Geotechnical Peer Review of Dr. S. Bernander's Reports and Analysis of the North Spur

02nd February, 2018

The objective of this report is to answer comments and questions that have been raised relative to the North Spur stabilization work by Dr. Bernander and colleagues. The GPRP finds seven main issues raised by Dr. S. Bernander and R. Dury. These issues are: i) the type of the landslides in the study area, ii) the "extreme sensitivity and particular structure" of the soils in the North Spur, iii) the application of the limit equilibrium approach to evaluate stability of the North Spur, iv) aspects of progressive failure, v) the impact and consequence of an earthquake on the stability of the North Spur, vi) the efficiency and relevance of the mitigation works, and vii) the consequences of a potential landslide and downstream flood.

Figure 5: Typical grain size distribution curves for the Upper Clays at the North Spur (courtesy Muskrat Fall Corporation).

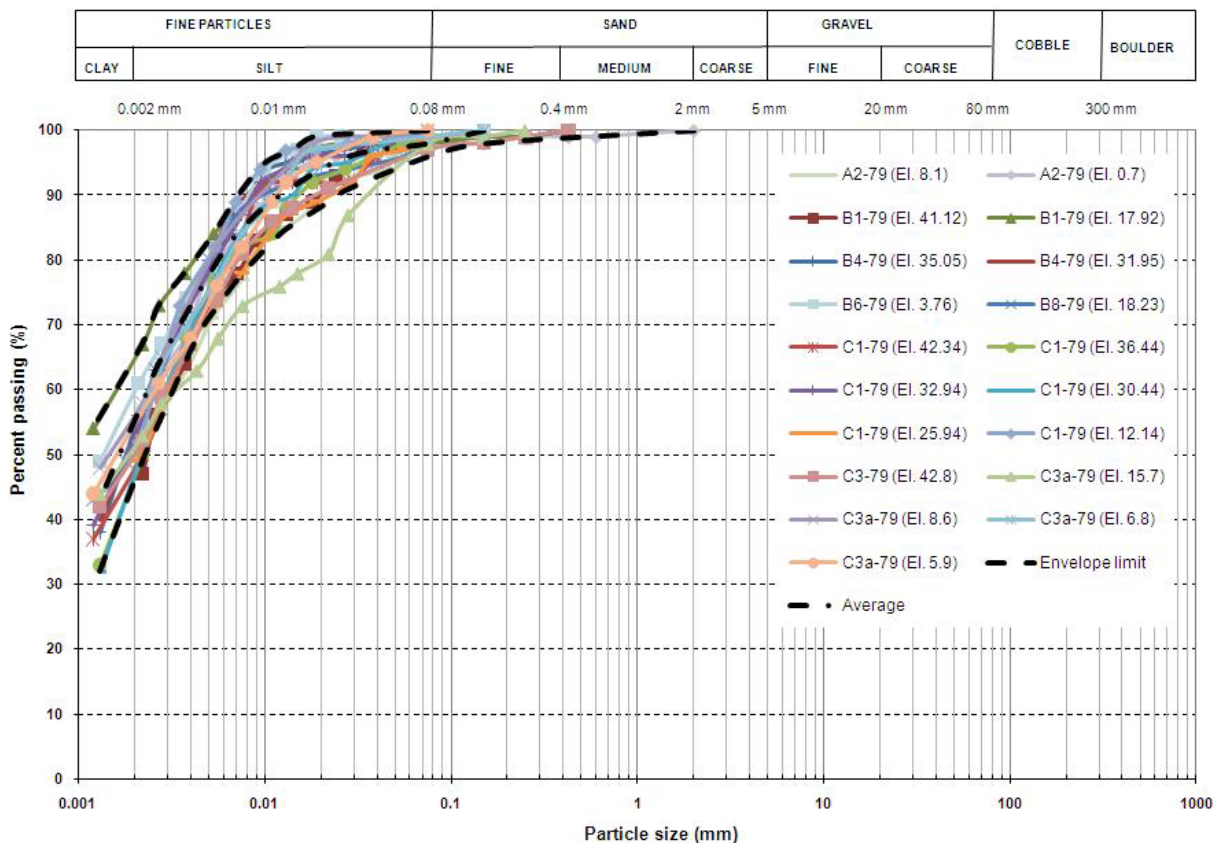
Dr. Bernander refers to the Upper Clay as follows: “presence of extremely lean clays mixed with sand and silt” (p. 18, 2015 Report; ref. (4)). He also writes: “This means that the clay content of the mixed soil is highly under-consolidated, thus indicating propensity to soil liquefaction.” In addition, Dr. Bernander writes that the “Upper Clay layers 1 and 2 consist of mixed sandy/silty soils with very sparse clay content.” (p. 21, 2015 Report; ref. (4)). In his 2016 report, he interprets the Upper clay in a similar manner by writing: “The clay content of the Upper Clays and mixed silty sands of the Churchill River Valley is far below 30%.” (p. 20, 2016 Report; ref. (5)) and that this unit is “under-consolidated mixed lean clays or porous silty/sandy soils” (p. 20, 2016 Report; ref. (5)).

- Grain size analyses performed in 1979 show that the sand content is less than 4%, thus negligible, and the clay content is between 45% and 65% (Figure 5). Moreover, the grain size distributions do not show any gap in grain size between the sand particle size and the clay particle size as suggested by Dr. Bernander (Figure 5).

In the GPRP's opinion, the material description by Dr. S. Bernander is not a representative description of the Upper Clay at the North Spur. The Upper Clay at North Spur has only a few percent of sand, no gap in grain size between sand and clay, between 45 and 65% of clay particles and an average plasticity index of 11%.

Figure 7: Hydraulic conductivity results from in situ test results (see also Figure 4.22 of the SLI's Design Report; ref. (1)). The red line indicates the average hydraulic conductivity of the Upper Clay, while the blue line shows Bernander's interpreted value.

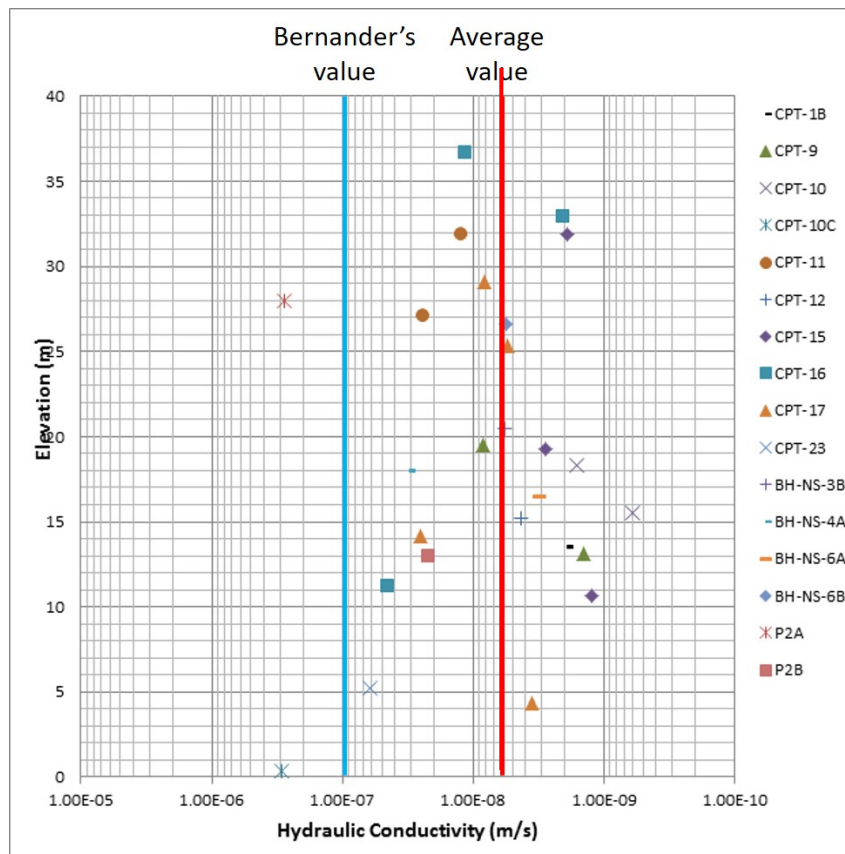
Dr. Bernander supports his soil description on the basis of the hydraulic conductivity measurements or inferences for the Upper Clay. Dr. Bernander interprets the hydraulic conductivity of the Upper clay to be a value of 10^{-7} m/s and finds that this value is high for a clayey soil. The GPRP agrees that a hydraulic conductivity of 10^{-7} m/s is high for a clayey soil.

Hydraulic conductivity values for the North Spur were estimated from *in situ* permeability tests and deduced from CPTU dissipation tests. The results are reproduced in Figure 7. The measured/inferred values vary between 6×10^{-10} and 3×10^{-7} m/s, with an average of 6×10^{-9} m/s (red line on Figure 7) compared to Dr. Bernander's value of 10^{-7} m/s (blue line on Figure 7). Typical hydraulic conductivity values in different soils are presented in Table 2 below.

Considering only the clay units, a representative value would be smaller than 6×10^{-9} m/s, more typical of the hydraulic conductivity of natural clays, such as those found in Eastern Canada clays (ref. (38)).

In view of the data at the North Spur, the GPRP does not agree with Dr. Bernander's description of the Upper Clay layers on the basis of hydraulic conductivity.

Figure 8. Section A (located on Fig. 3) through the North Spur and shear stresses applied on horizontal surfaces in the Upper and Lower Clays(s) before (BS) and after stabilization (AS) (from Leahy et al., 2017).

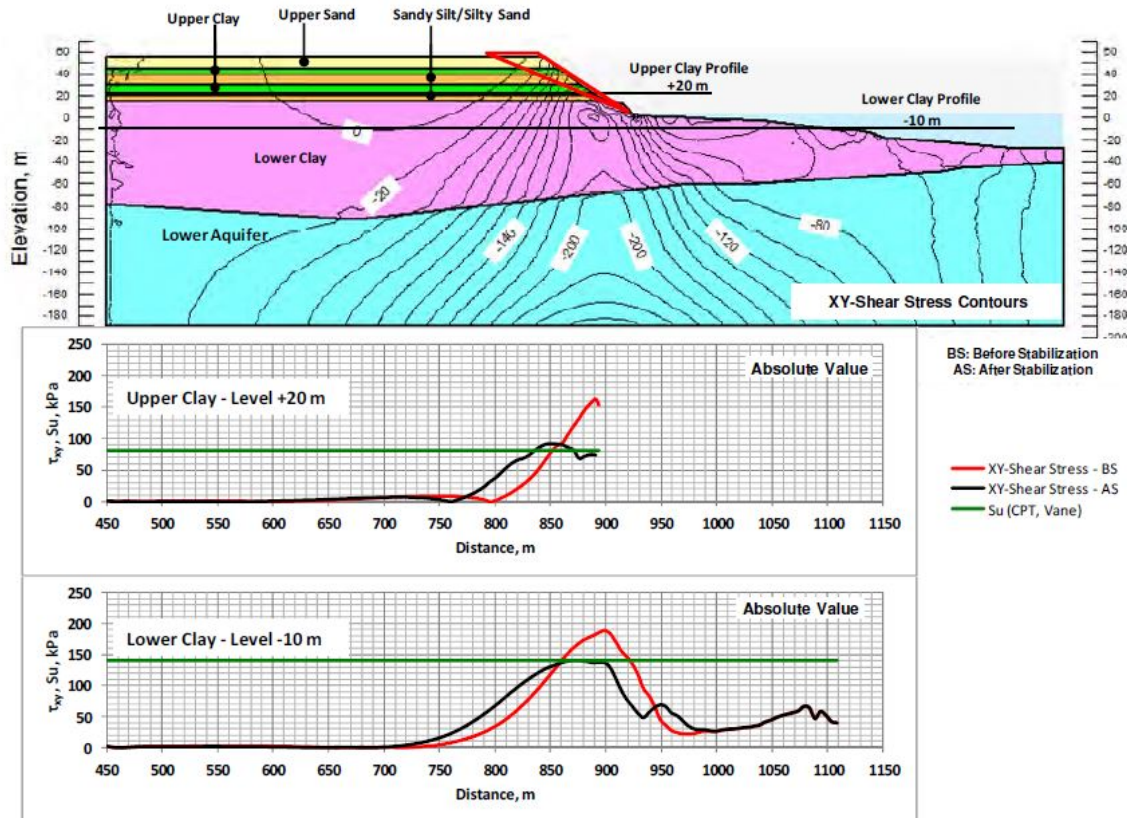
One of Dr. Bernander's main criticisms is that progressive failure has not been adequately taken into account by SLI. Progressive failure observed in sensitive clay is a function of their strain-softening behaviour and can be initiated either near the toe of the slope and progress inside the intact deposit or be triggered upslope and progress downward (refs. (32), (33), and (34)). In all cases, there must be a triggering factor bringing the soil to exceed its peak shear strength somewhere.

The soil was modelled as an elastic-perfectly plastic material and the calculations were performed for before and after the stabilization measures (discussed in Section 8) and also with full reservoir. As worst case scenario, SLI considered Section A (located on Fig. 3) where the safety factor of the slope was obviously close to 1.0. After stabilization works, the safety factor was expected to increase to 1.6. The calculated shear stresses on horizontal planes at elevation +20 m (Upper Clay) and -10 m (Lower Clay) are shown in Figure 8. It can be seen that before stabilization (red lines), the maximum shear stresses are respectively 162 kPa and 188 kPa on both surfaces. SLI considered these values as reference shear strengths for other analyses. Figure 8 also shows reductions of 45% at elevation +20 m and 25% at elevation -10 m of the maximum shear stresses after the stabilization works (black lines).

Figure 11: Cross-section A-A' of the slope with the cut-off wall on the upstream side of the Spur (Courtesy Muskrat Falls Corporation).

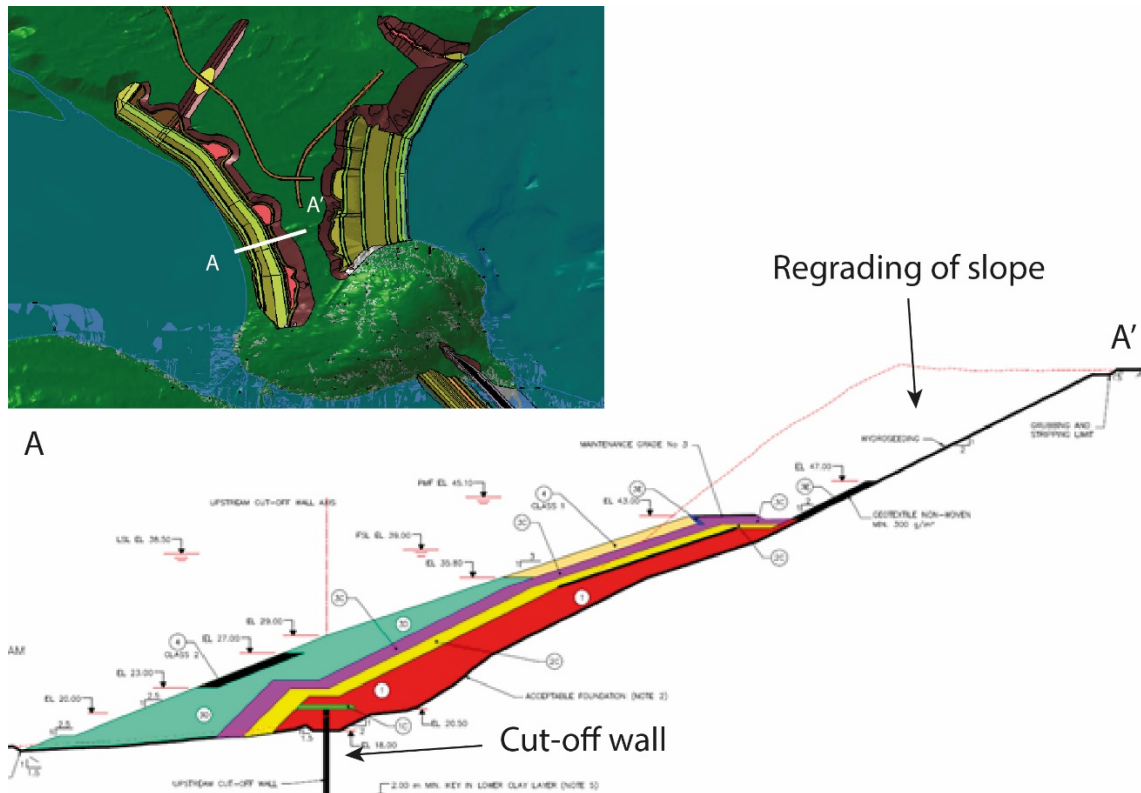
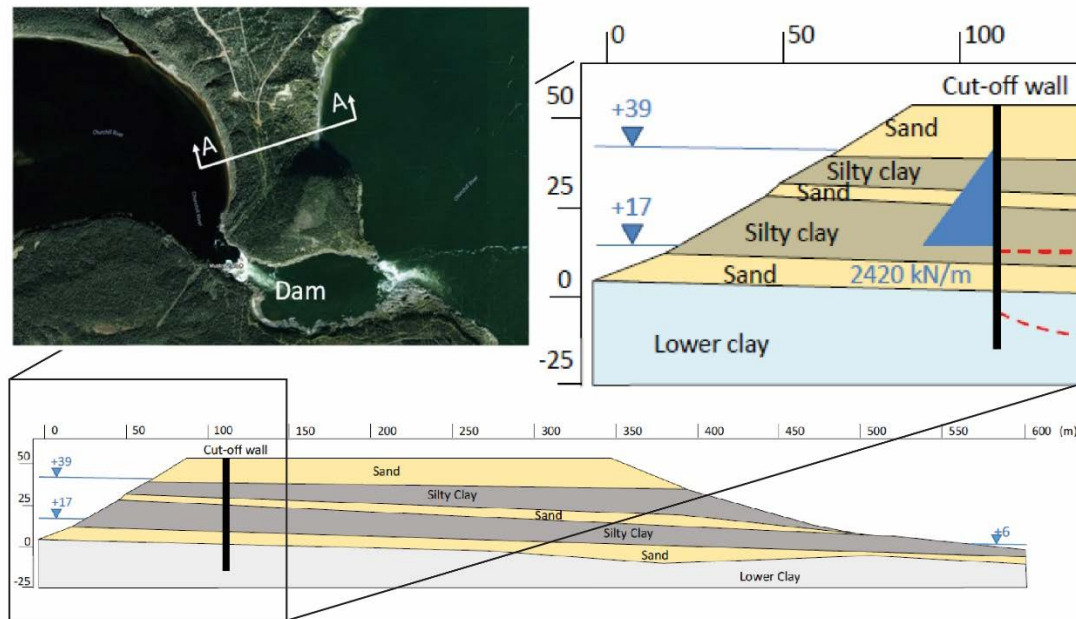
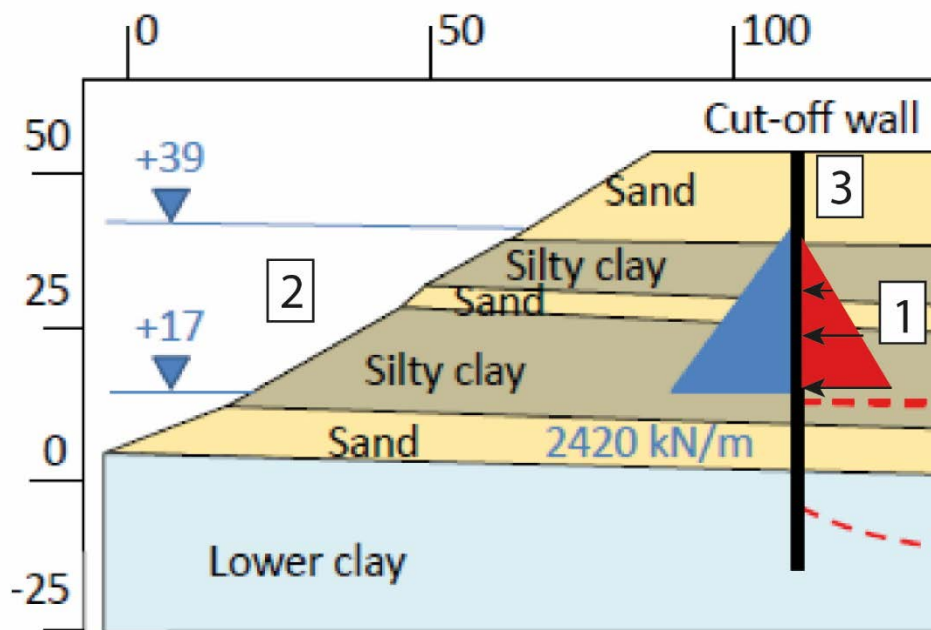
The COW on the upstream side of the Spur is located near the toe of the slope and is superimposed by a till blanket acting as an erosion barrier and counter fill (Figure 11). However, in his analysis, Dury assumed an impermeable COW located well within the crest of the slope and without the presence of the till blanket (Figure 12). Moreover, the elevation and height of the COW in Bernander's analyses is very different than the actual COW location. In reality, the top of the COW is slightly above +22 m while Bernander's assumes an elevation of the COW at around + 50m. SLI reported, based on recent surveys, piezometric water head slightly below +39 m (similar to full reservoir level) in the piezometers located behind the COW and till blanket. This water pressure is likely coming from water infiltration from the ground surface in the North Spur.

In their analyses, Dury and Bernander assumed "a gigantic external force (locally on the COW)", assuming the water pressure resulting from impoundment on only one side of the COW (blue triangle on Figures 12 and 13), in addition to using incorrect geometry and incorrect location for the COW. Actually, the many piezometers installed in the North Spur show that the water pressure in the Spur will be acting on both sides of the COW (red triangle on Figure 13). If the calculation is performed for a COW at the actual location, the force on the wall will be much less than the force calculated by Dr. Bernander.

The GPRP finds that the COW analysed by Dury and Dr. Bernander is not representative of the actual COW and till blanket on the North Spur. The GPRP does not expect that the cut-off walls will "create a gigantic force", as calculated by Dury and Bernander, which could trigger a downward progressive failure. Actually, the existing piezometer data show that water pressure within the Spur is already at a level similar to the level of the reservoir after impoundment.

Figure 14: Overview of finger drains on the downstream side of the Spur (picture courtesy of Muskrat Falls Project).

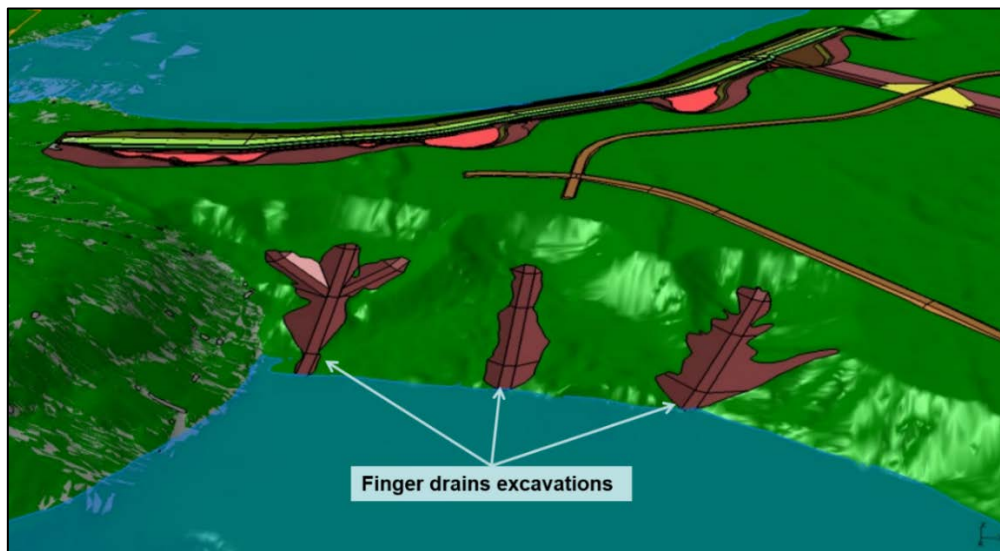
SLI designed and recommended the installation of finger drains on the downstream side of the Spur to improve drainage of the slopes and hence the stability of the slopes. In his reports (ref. (4) (5)) Dr. Bernander acknowledges that the finger drains will enhance and maintain the drainage of the slopes on the downstream face of the Spur. However, he stipulates that the drains will have no effective guarantee against progressive failure development.

The GPRP agrees that the finger drains are necessary to maintain appropriate drainage on the slopes on the downstream face of the North Spur and to reduce infiltrations. However, the drains will also, to some extent, increase the local stability of the slopes and thereby reduce the susceptibility of an initial failure occurring on this side of the North Spur (which is the main function of these drains).
